**Proposed redevelopment of church at 58a Birkenhead Street, 2024/5792/P**

We are the owner-occupiers of 59 Birkenhead Street. This is the Vicarage that was originally built with the church, which shares a large wall with it, and which is itself a Grade II listed building.

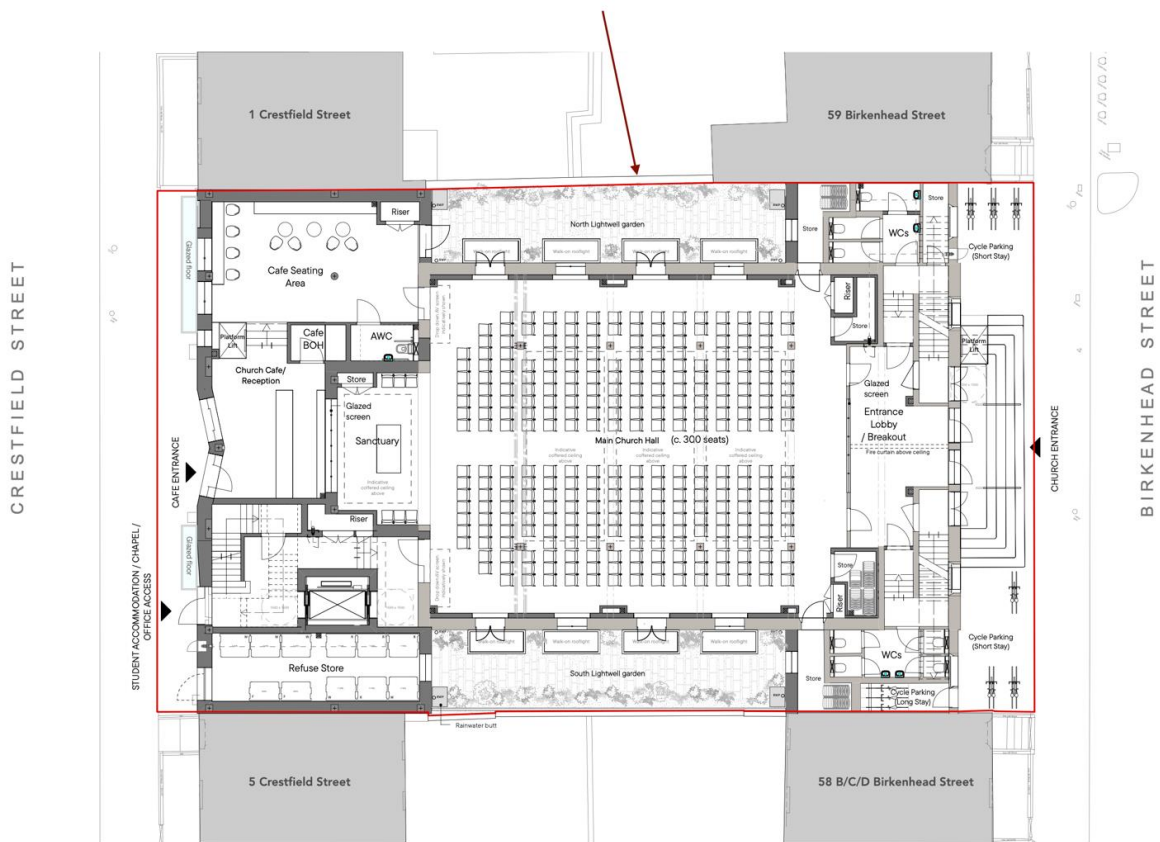
As in diagram below (Proposed Ground Floor Plan), the extent of 59 Birkenhead St is not shown correctly and a window facing directly onto the proposed garden is not shown. No mention is made in the proposal or the light survey of this window, which will be almost completely covered by the raised outdoor space bordering it. Planning and amenity issues surrounding this window are not addressed.

Plan does not show existing building nor the window which faces directly onto the proposed lightwell garden. Privacy issues not addressed nor any impacts on light and sky to this window.

We ask that the planning and amenity issues, including light and sunlight, revolving around the ignored window on the south side of our property be addressed in the light of an accurate plan.

Figure 1: Equipment location, measurement position, and closest receptor (available at [google.com/maps](https://www.google.com/maps))

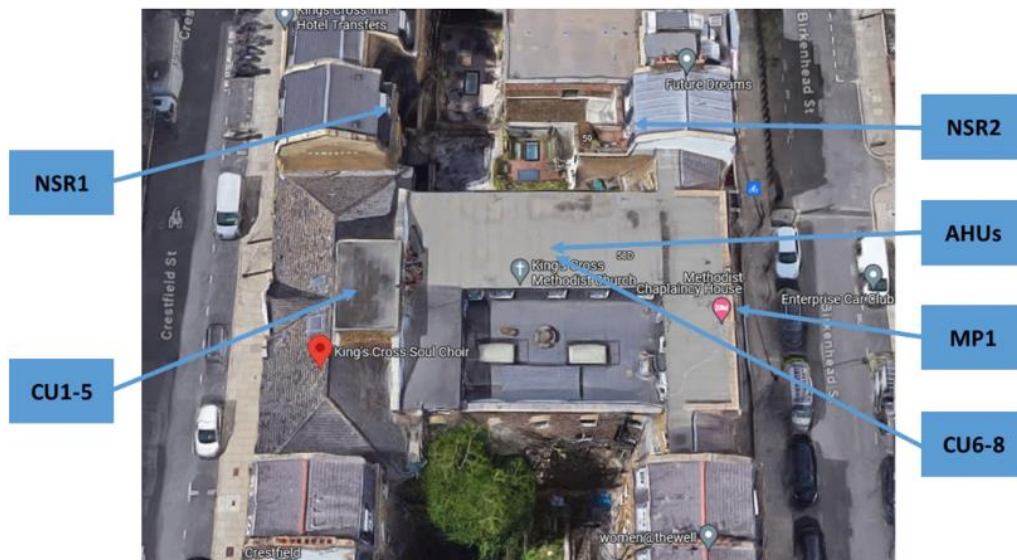
The acoustic assessment has not made a proper assessment of background noise levels to the rear windows or outdoor areas to 59 Birkenhead Street. Noise levels were recorded at 'MP1' in both noise reports which faces directly onto the street and is therefore almost certainly louder than the window location used for the assessment, NSR2 (diagram below).

Thus the following statement, and possibly others, cannot be relied upon, "Table 6 shows the rating level of the proposed new equipment will be at least 10dB below the background LA90 sound level to outside the closest noise-sensitive properties."

The model used to make the estimates has not been disclosed. However, it is clear that this model makes no attempt: to account for the reduction in background sound level to be expected from the increased enclosure of NSR2 by the larger edifice of the church; to include the stops and starts of noise, which are liable to be the aspects of any machinery that disrupts sleep the most, including failing to disclose the operating parameters in this regard provided by the manufacturers of the equipment and expected usage patterns; to account for the additive effect of the two bedroom openings that face the machinery; to allow for the reflection of sound, including reverb, from the enclosing buildings; to incorporate noise from sources not in the main machinery space (for example in the plant room and as shown on the roof plan). These deficiencies again undermine the conclusions drawn.

- Improve the realism of the model by re-measuring the background noise levels and taking account of the several complicating factors mentioned above

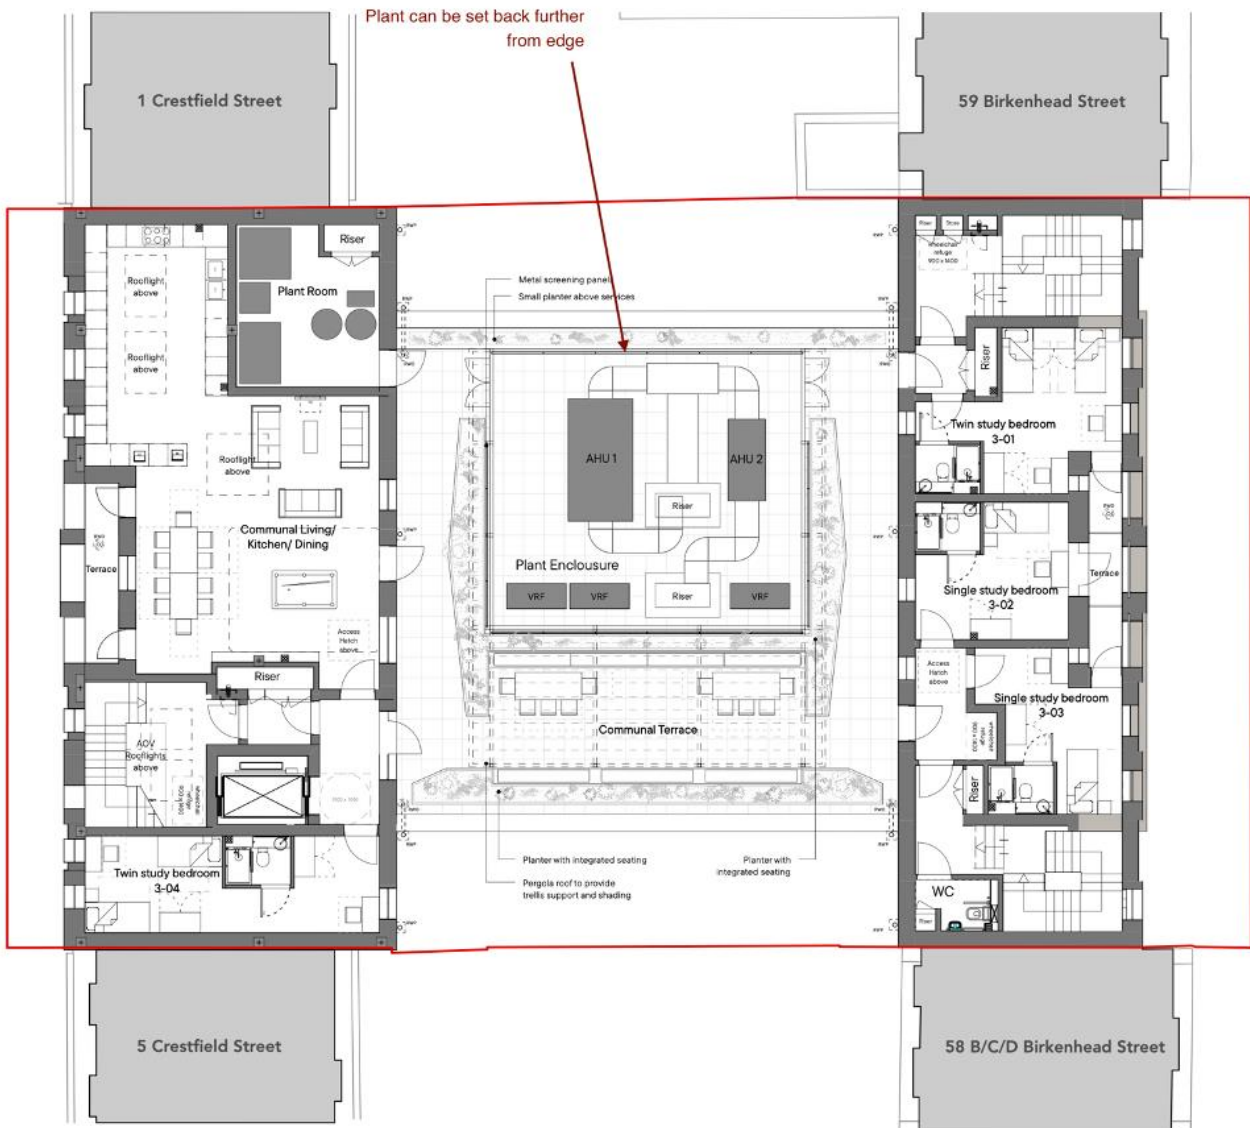
- Whatever machinery is ultimately required, move it away from our bedroom and improve insulation (diagram below)
  - To reduce noise and odours, re-route the ventilation from the kitchens so that it exhausts on to Crestfield St; provide an enforceable limit for odours.
